Proposal from India for draft amendment in Motorcycle Brakes GTR
i.e the document
TRANS/WP.29/GRRF/2005/18, dated 3rd August 2005

Transmitted by the expert from India

India's comments on document:
TRANS/WP.29/GRRF/2005/18, 3 August 2005
GLOBAL TECHNICAL REGULATION ON MOTORCYCLE BRAKE SYSTEM

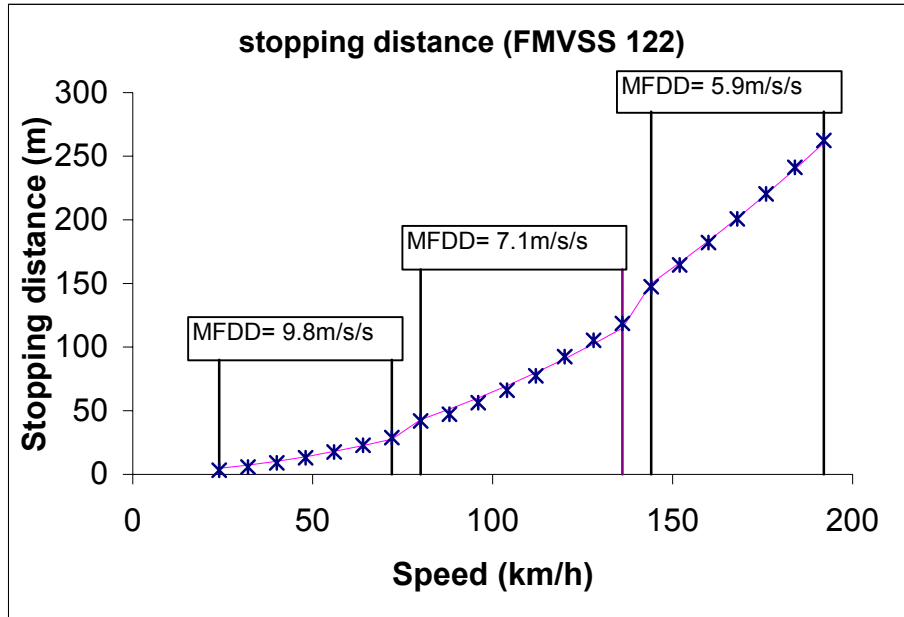
Para 4.4.3

When the brakes have been tested in accordance with the test procedure in 4.4.2, the stopping distance (S) *or the MFDD* shall be:

- *$S \leq 0.1 V + V^2/149$ or MFDD 5.8 m/s^2 in case of vehicles with $V_{max} \leq 125\text{km/h}$*

- *$S \leq 0.1 V + V^2/196$ or MFDD 7.5 m/s^2 in case of vehicles with $V_{max} > 125\text{km/h}$*

- MFDD may be added as an alternate to stopping distance.
- Separate requirement may be specified for vehicles with V_{max} less than 125km/h and more than 125 km/h in line with our proposal on para 4.4.2.
- As per FMVSS-122, calculated MFDD values would be the following:
For test speeds upto 72km/h: 9.8m/s^2
For test speeds 80-132 -km/h: 7.1m/s^2
For test speeds 140 to 192km/h: 5.9 m/s^2
The MFDD prescribed in the draft GTR of 7.5m/s^2 at speed of 100km/h itself is higher than the calculated one as per FMVSS.
With lower test speeds, an MFDD of 7.5 m/s^2 would not be achievable and hence India suggests that for vehicles with V_{max} less than 125km/h the MFDD prescribed in ECE R 78

India also feels that even in the case of vehicles with Vmax more than 125km/h, MFDD of 5.8 can be adopted.

The following Graph would substantiate the proposal

The stopping distance specified in FMVSS 122 for different speeds for the test with both the brakes applied do not fit into an equation of $0.1V + KV^2$. It is found that reasonable fit is obtained if regression is done by splitting the test speed into different ranges. The results of this regression is shown in the following figure.
